A303 Amesbury to Berwick Down

Deadline 7
8.45 - Errata Report

ERRATA Report

Regulation Number:	Regulation 5(2)(q)
Planning Inspectorate Scheme Reference	TR010025
Application Document Reference	8.45
Author:	A303 Amesbury to Berwick Down Project Team, Highways England

Drawing Title: **FIGURE 1**
MAP OF SOUTHERN ENGLAND SHOWING THE LOCATION OF BRIDGE SAMPLING SITES

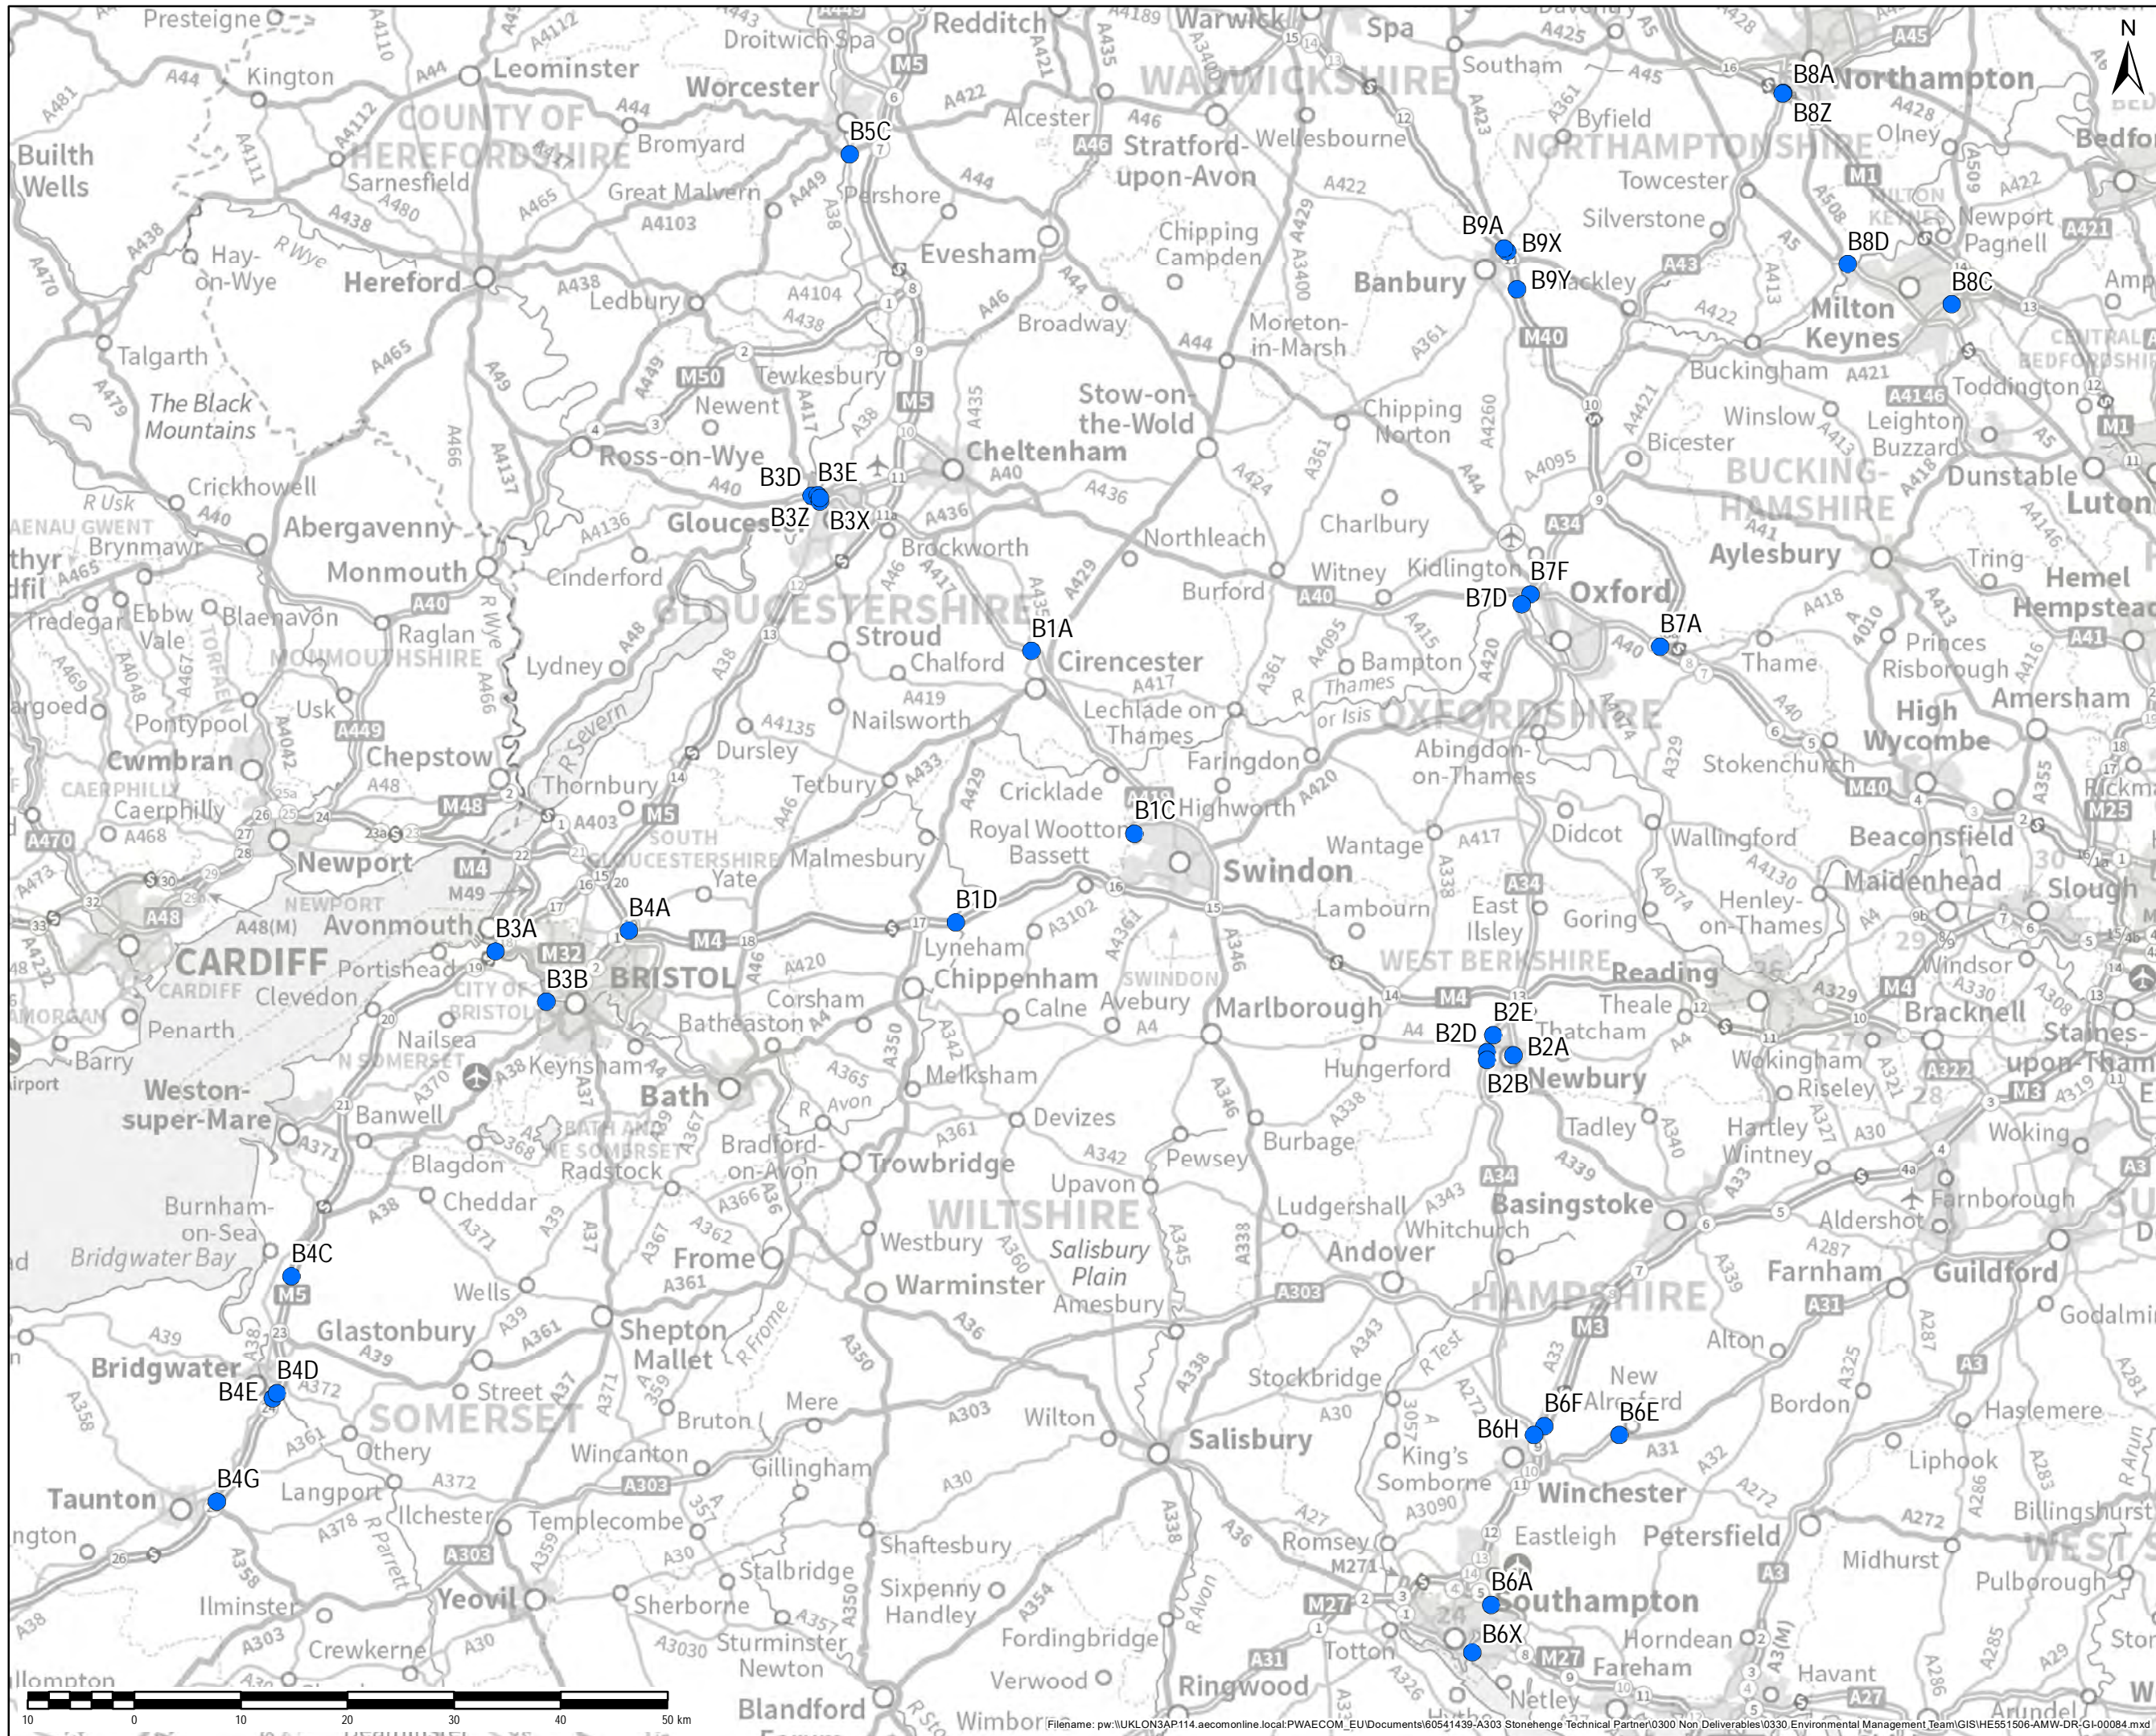
Tree ID	Works to Facilitate the Proposed Scheme	G22	Fell	G296	Fell	G874	Fell in part	G1002	Fell	T1004	Fell	T1005	Fell	T1006	Fell	T1007	Fell	G1019	Fell	1098	Fell in part
Tree ID	Works to Facilitate the Proposed Scheme																									
G22	Fell																									
G296	Fell																									
G874	Fell in part																									
G1002	Fell																									
T1004	Fell																									
T1005	Fell																									
T1006	Fell																									
T1007	Fell																									
G1019	Fell																									
1098	Fell in part																									
APP-244 and APP-246	Appendix 8.7A and Appendix 8.9B	N/A	Covers on Reports	<p>[APP-244] Environmental Statement Appendix 8.7B Aquatic Macrophyte Survey River Till – contains [APP-247] Appendix 8.9B Aquatic macro-invertebrate survey and</p> <p>[APP-246] Environmental Statement Appendix 8.9A Aquatic Macroinvertebrate Survey River Avon – contains [APP-243] Appendix 8.7A Aquatic Macrophyte Survey River Avon</p> <p>The correct reports are provided within Appendix B of this Errata Report.</p>																						
APP-266	Appendix 8.25 Habitat Regulations Assessment	Appendix D (in Appendix A)	Fig 1. Map of Southern England Showing	Figure 1 Map of Southern England Showing Location of Bridge Sampling Sites is now provided, see Appendix C of this Report.

Document no.	Document name	Section and Paragraph Reference	Nature of Erratum and Explanation	Replacement Text
	(HRA): Statement to Inform Appropriate Assessment		Location of Bridge Sampling Sites - the map is not included.	
APP-280	Appendix 11.2 - Water Framework Directive Compliance Assessment	Section 7.2 Paragraph 7.2.5	An assessment of the potential impact of non-native species within the River SAC (which includes the River Avon and River Till) as a result of the Scheme was undertaken as part of the Habitats Regulations Assessment but this was not referred to within the WFD Compliance	New paragraph to be added after the existing paragraph 7.2.3: <i>“The spread of non-native/invasive species was considered as part of the Habitat Regulations Assessment screening assessment for the River Avon SAC (which includes the River Avon and River Till) as outlined in Table 3.1 of Appendix 8.24 - Habitat Regulations Assessment (HRA) Likely Significant Effects Report of the Environmental Statement (APP-265). This assessment concluded that there would be no likely significant effect as there are no invasive species present in the section of the River Till SAC where works will take place, the contractor will implement control measures as necessary to prevent the introduction or spread of invasive species in order to comply with the Wildlife & Countryside Act 1981 and the Scheme will not create changes to land management.”</i>

Appendix C - Figure 1 Appendix D (in Appendix A in Appendix 8.25)
